TE Connectivity

Product Change Notification: P-26-030969

MALE HSG / ISL FIT IMPROVEMENT

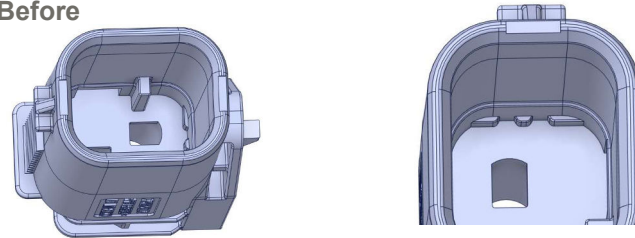
During SL inspection, multiple cases of unexpected lock activation were identified, showing an approx. 1.5% fallout rate associated with this failure mode.

An initial evaluation identified a noticeable gap between the housing and the ISL. A rattle effect is present, indicating excessive clearance between mating components. This condition may be contributing to the unwanted lock activation.

BEFORE AND AFTER COMPARISON

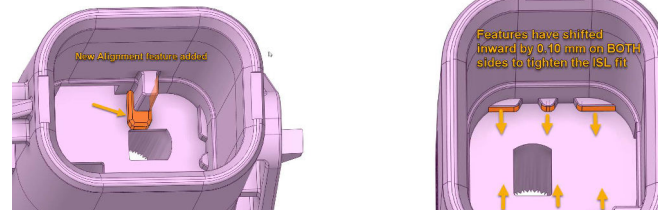
- Male Housing p/n 2482012 and ISL p/n 2482016 fit and alignment has been improved to eliminate any ISL shifting during shipping, prior to terminal installation.

- To improve the fit and retention of the ISL during shipping, prior to terminal installation a lower alignment rib has been added in the housing that prevents the ISL from over rotation.
- The housings 2x ISL guiding side walls have also been tightened 0.10 mm per side to reduce overall ISL displacement and movement during transit.
